Summary of principle objections:

Issue	Response
<p><i>Height/Character -</i> Fails to comply with Clause 15.4.1 P1</p>	<p>A very detailed response to each matter to be considered under Clause 15.4.1 P1 is provided on pages 51-63 of the GHD Planning Report accompanying the application. This response seeks to demonstrate that the proposal complies with Clause 15.4.1 P1 with the use of renders from a number of key vantage points, an assessment undertaken by a Landscape Architect, and responses by experienced planners to each of the performance criteria.</p>
<p>Hotel is a stunning concept but totally out of character with the area and will detract from the natural backdrop of the Gorge. Use of glass and concrete as building materials is out of character with the surrounds</p>	<p>The planning assessment report provides extensive assessment of the surrounding streetscape and character in relation to the height of the building (pgs 51-55) and again on pages 64-67 in relation to setbacks.</p>

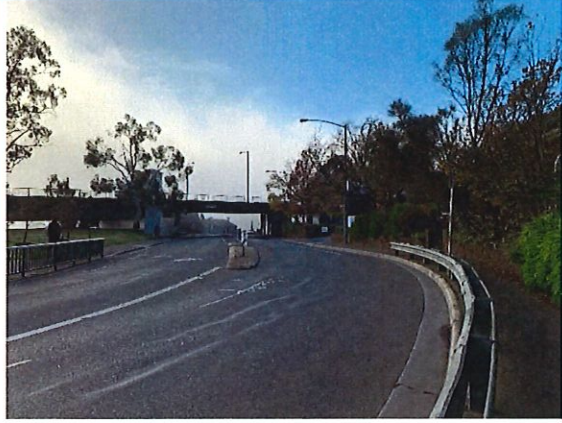
<p>The scale height and proximity of the hotel will negatively impact on the Gorge</p>	<p>It is noted that the Cataract Gorge Management Area Code does not apply to the application.</p> <p>The Landscape and visual impact assessment prepared by GHD has demonstrated that the hotel would not inhibit views of the Gorge from the viewpoints that were assessed. This included three 'Prime viewpoints' as identified in the Cataract Gorge Management Area, namely:</p> <ul style="list-style-type: none"> • Viewpoint 3 – Kings Bridge • Viewpoint 8 – Tamar Yacht Club • Viewpoint 11 – Cimitiere St <p>Other viewpoints also demonstrated that views toward the Gorge would not be impacted, including:</p> <ul style="list-style-type: none"> • Viewpoint 6 – Paterson Street • Viewpoint 7 – Kings Park • Viewpoint 9 – Home Point Cruise Terminal • Viewpoint 10– Kings Wharf Road • Viewpoint 12– Windmill Hill Reserve <p>Further, it is submitted that the hotel will not impede views into the Gorge from any entry locations. For people travelling north along Margaret Street there is currently no view of the Gorge entry and for people travelling west along Paterson Street, the</p>

setback of the tower means there will be no impact of views into the Gorge. In fact, the greatest impediment of views into the Gorge is the Paterson Street bridge as shown in the image below which is taken opposite Stillwater:
